Taming CSRS

Piers Dawe

Avago Technologies

Comments vs. D3.1 about spec limits and margin

Relative difficulty of stressors with noise loading

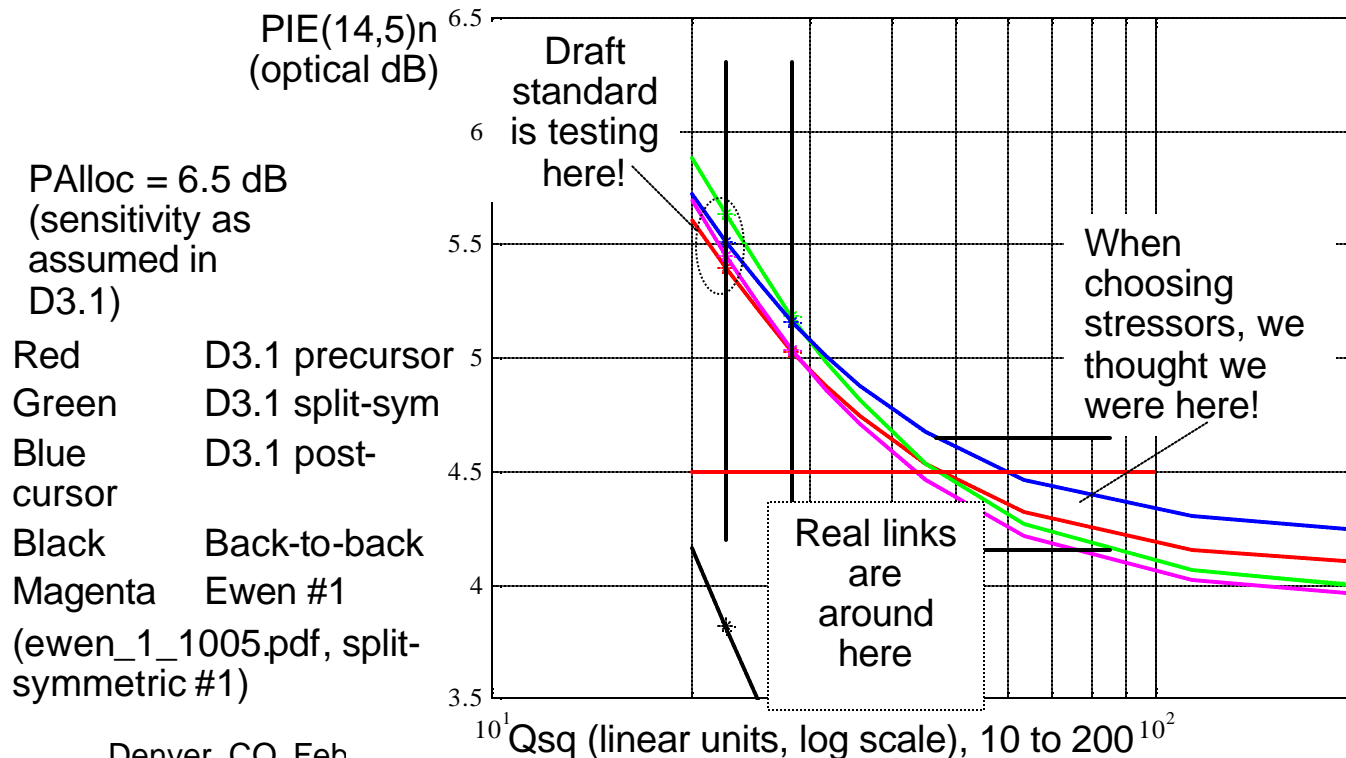
D3.1 split-sym (green) is worst affected

Gradient ~ 0.3 dBo or 0.6 dBe per 1 dBo of stressor noise
Contributes to test uncertainty

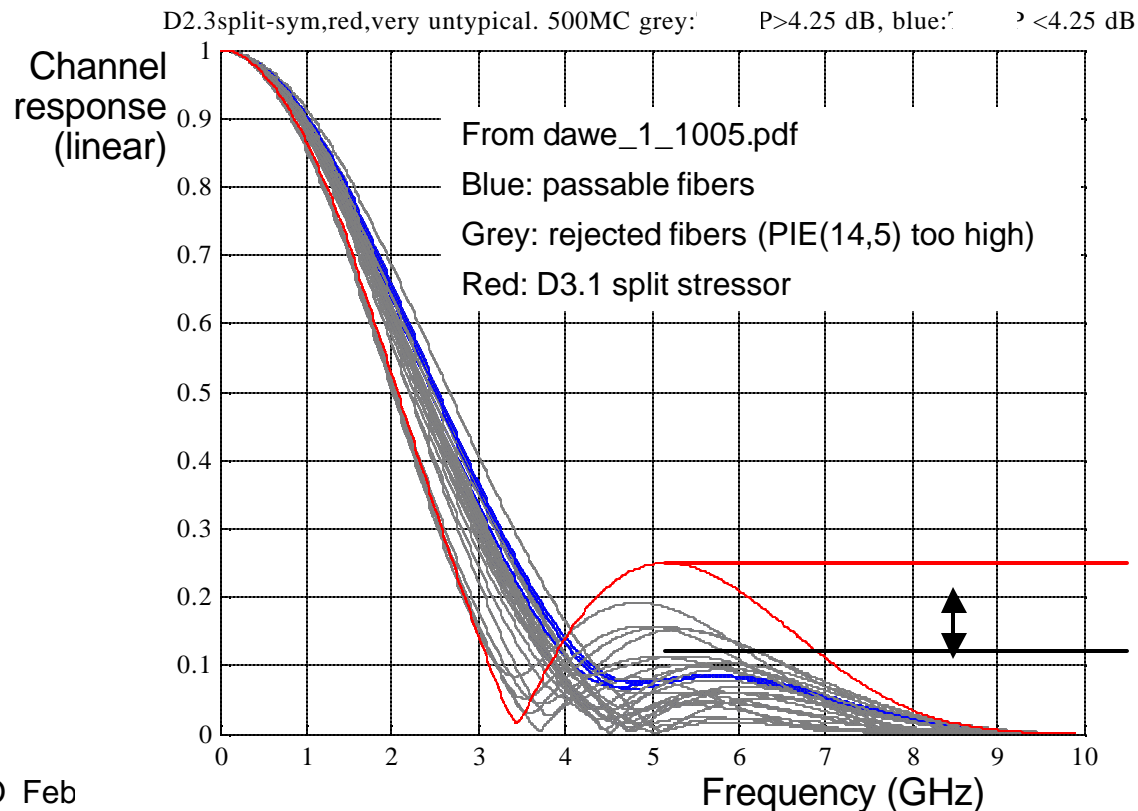
Current split-sym (red) very unrealistic: notch too deep, bounce-back too high

NO fiber responses have this much bounce-back: split stressor is too clean and unrealistic

Quantifying the rarity of a very deeply notched channel

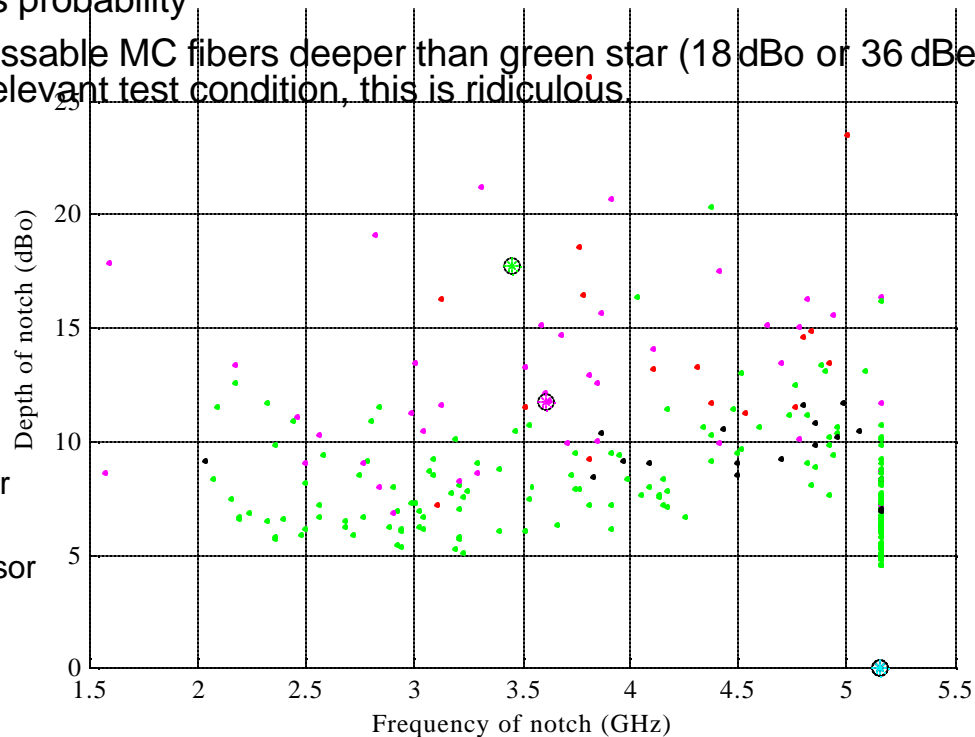
- Asterisks circled in black: stressors
- Deep notches for passable MC fibers absent below 2 GHz
- Only 8 in 4000 passable MC fibers deeper than pink star (12 dBo or 24 dBe notch) and $PIE(14,5)_n < 5.5$ dBo: all above 4 GHz. These are rare enough to ignore. Any evolution of center launch through time may raise this probability

- Only 1 in 4000 passable MC fibers deeper than green star (18 dBo or 36 dBe notch) and $PIE(14,5)_n < 5.5$ dBo. As a relevant test condition, this is ridiculous.

Proposed lower-noise test points

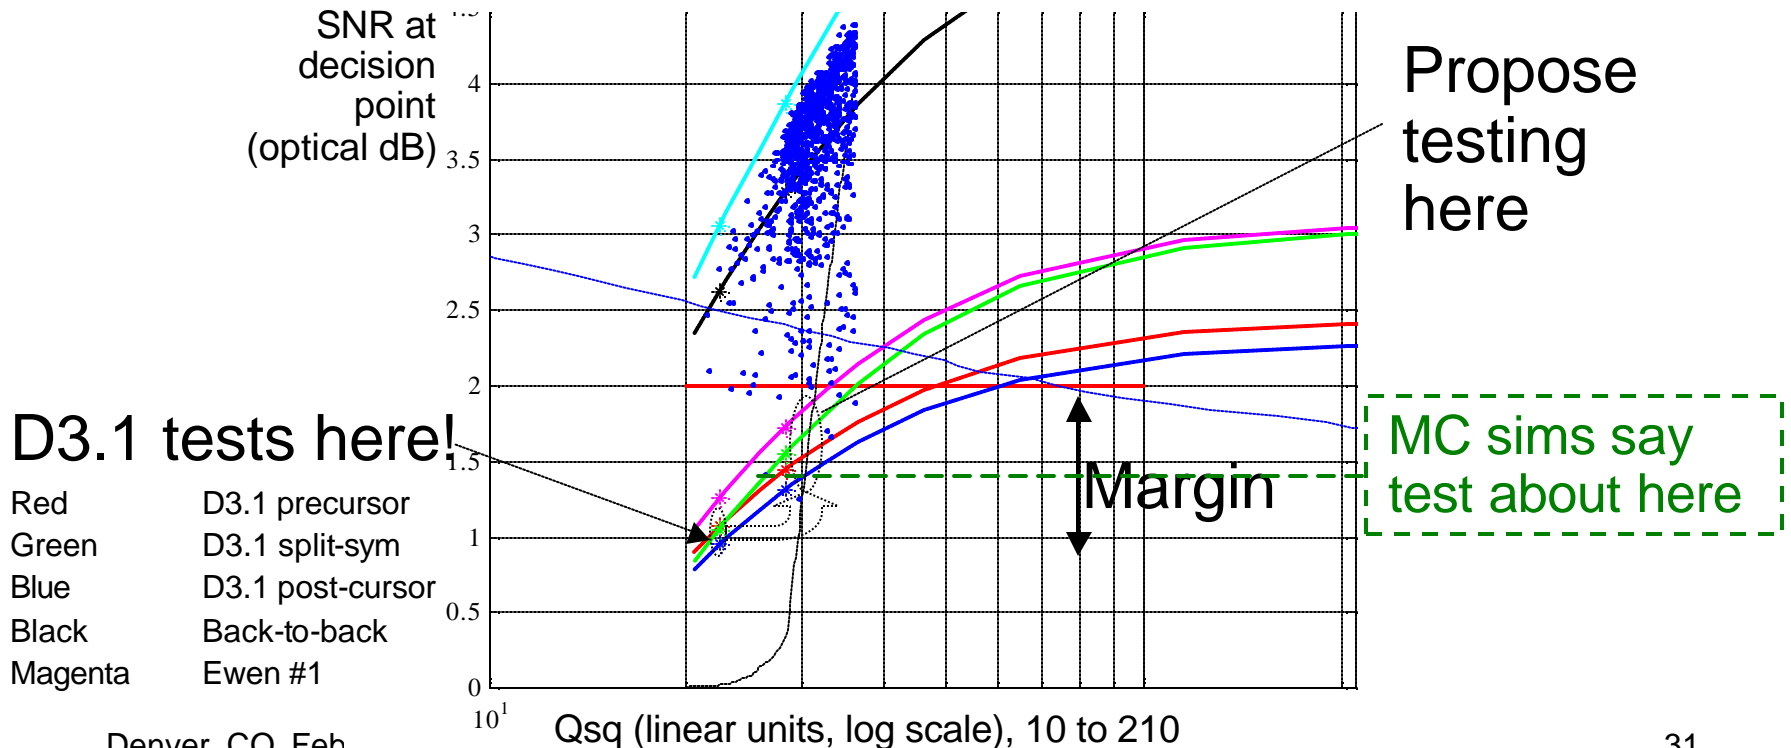
- Propose moving Qsq to 30 and changing split stressor to “John Ewen #1”
 - Gradient of penalty vs Qsq is less: reduced errors
 - Effect of noise color must be less: reduced errors
 - Smooth stressors (pre and post) at the right margin vs MC sims – these stressors are more like the majority of real channels and define coverage
 - Unnatural green split stressor replaced by more moderate magenta “John Ewen #1” – tests for receiver’s versatility rather than defining coverage
